**Town of Kittery  
 Planning Board Meeting  
 October 13, 2022**

**28 Wyman Avenue — Sketch Plan Review, Cluster Residential Subdivision**

**RE: Town of Kittery, Planning Board Services  
Wyman Hill Cluster Subdivision  
28 Wyman Avenue, Tax Map 16, Lot 148  
CMA #591.151**

**STANDARD DUTY ASPHALT PAVEMENT NOT TO SCALE**

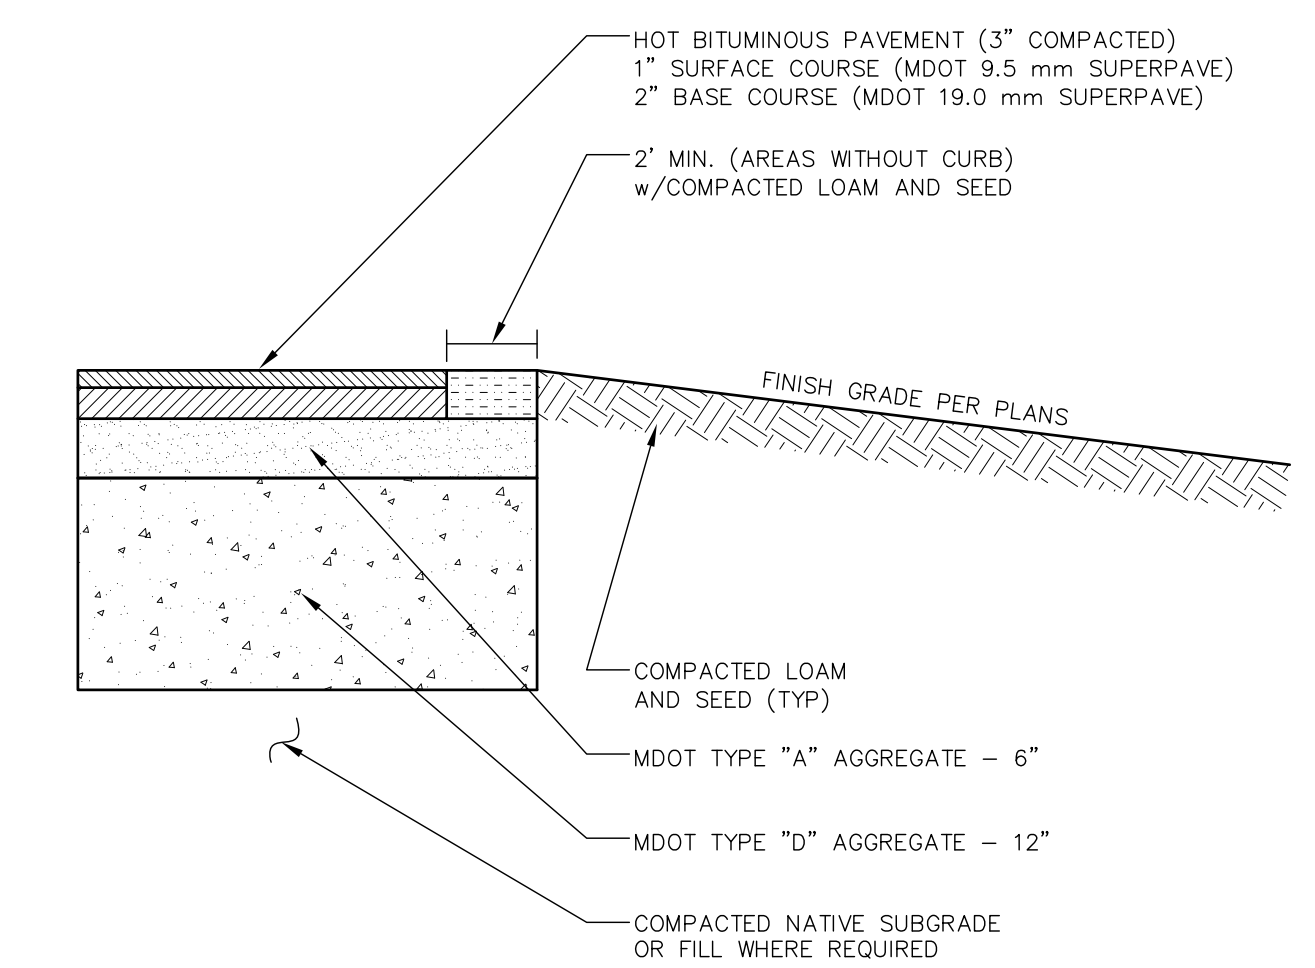
- Include a detail for the roadway and the shared driveway.
- Update the Notes for the Standard Duty Asphalt Pavement detail to apply to this project.
- The Water Service Connection details should specify 2" DR11 service lines.
- Is a stop bar proposed at the intersection with Wyman Avenue? Please provide a detail.

**DRAINAGE & SEWER TRENCH**

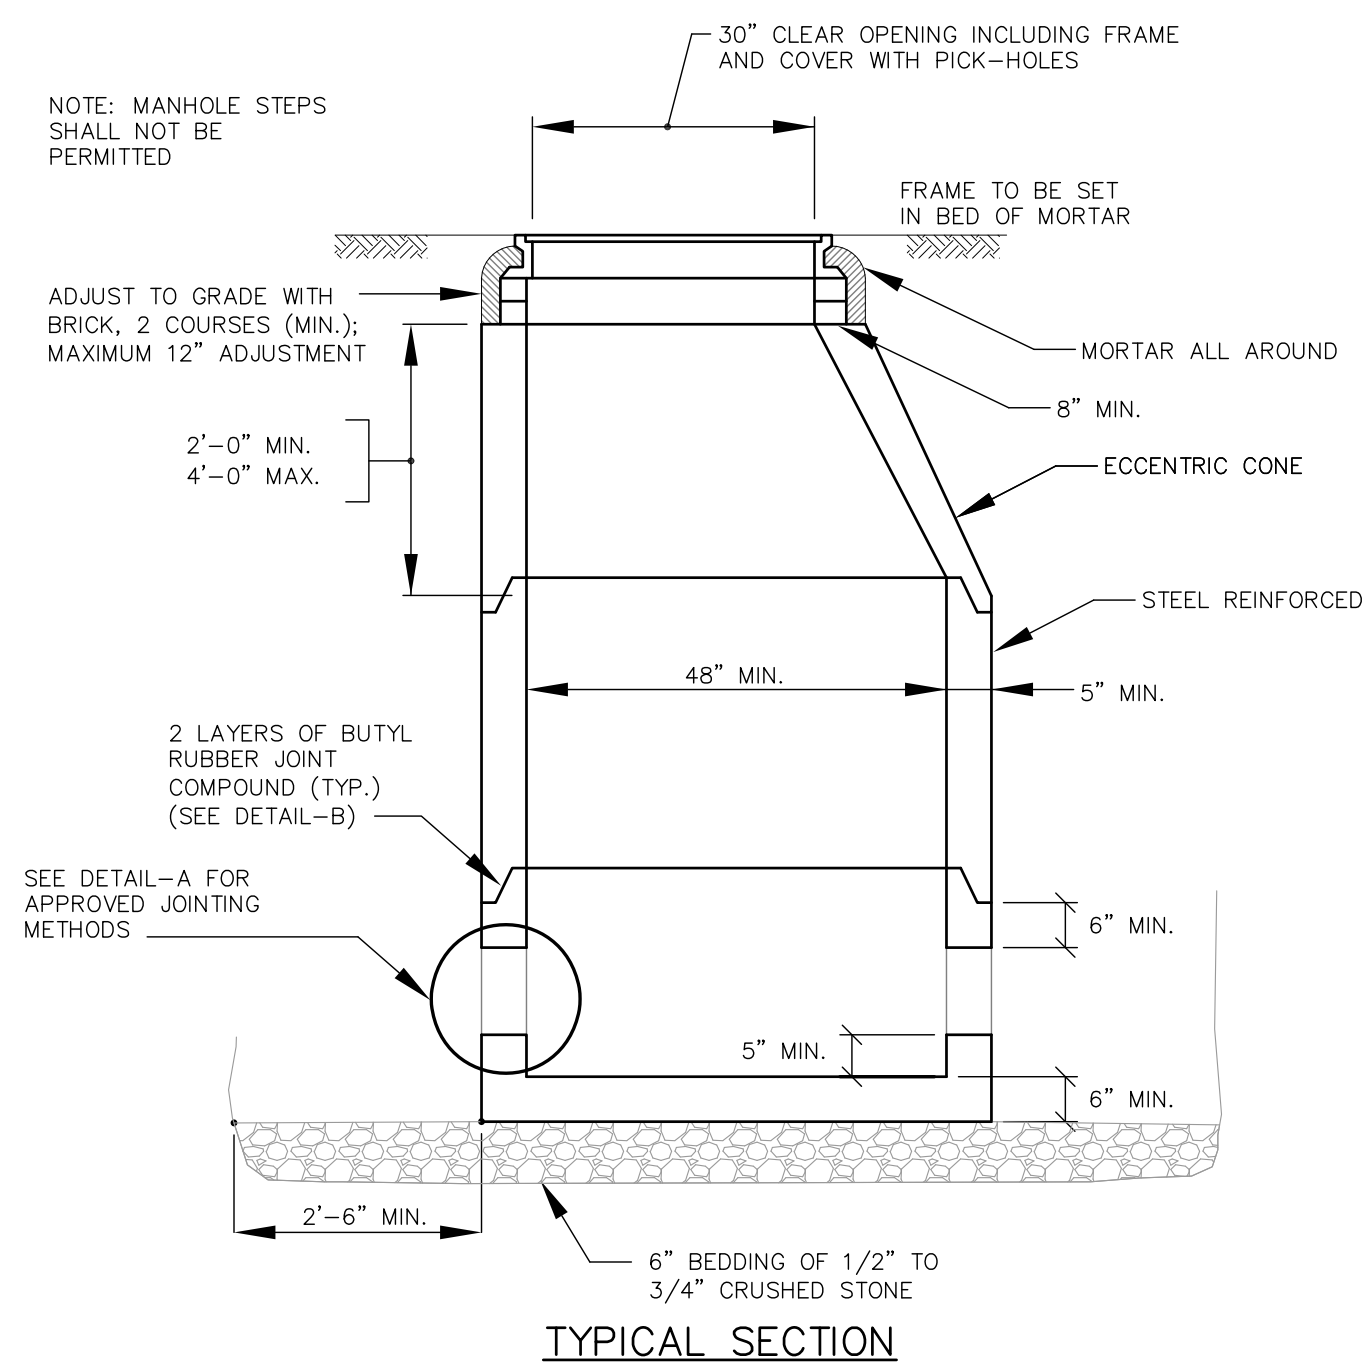
- Remove the wood sheeting from the Drainage & Sewer Trench detail.
